SEWAGE DISPOSAL SYSTEM

MARYLAND STATE DEPARTMENT OF HEALTH

HOWARD COUNTY

SUBDIVISION Glenwood Estates ROAD 3690 Sully Road LOT 42

PERMIT 2-493

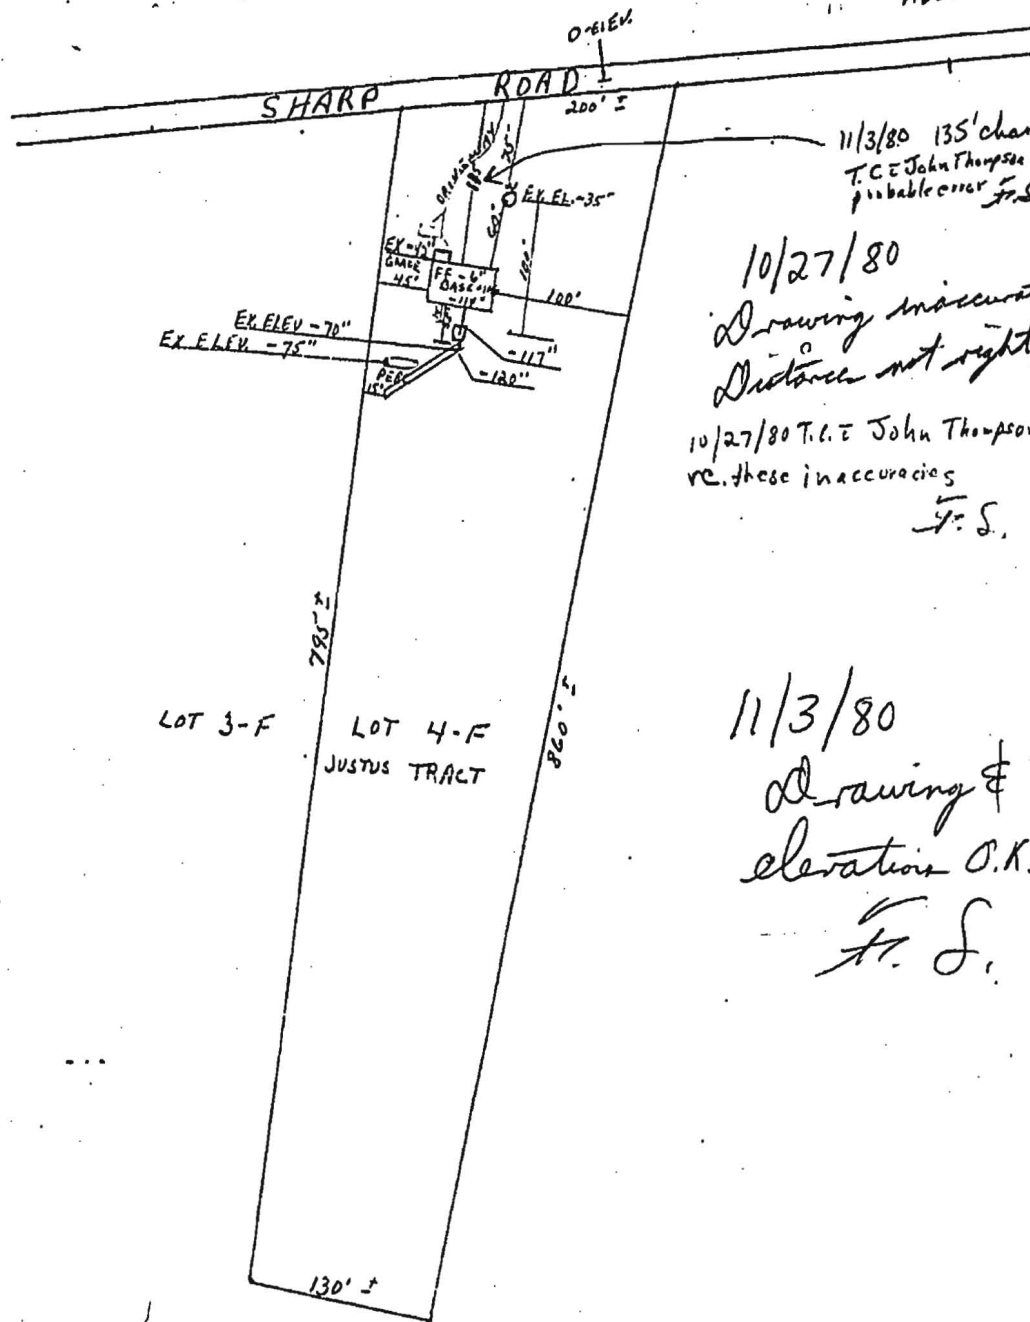
REMARKS 1/22/81 OK to add gravel in trench #8

1/23/81 OK to cover all with #4 SK

11/3/80 135' changed to 15'
T.C. & John Thompson re this
probable error F.S.

10/27/80
Drawing inaccurate
Distances not right F.S.
10/27/80 T.C. & John Thompson's partners
re these inaccuracies
F.S.

11/3/80
Drawing &
elevations O.K.
F.S.
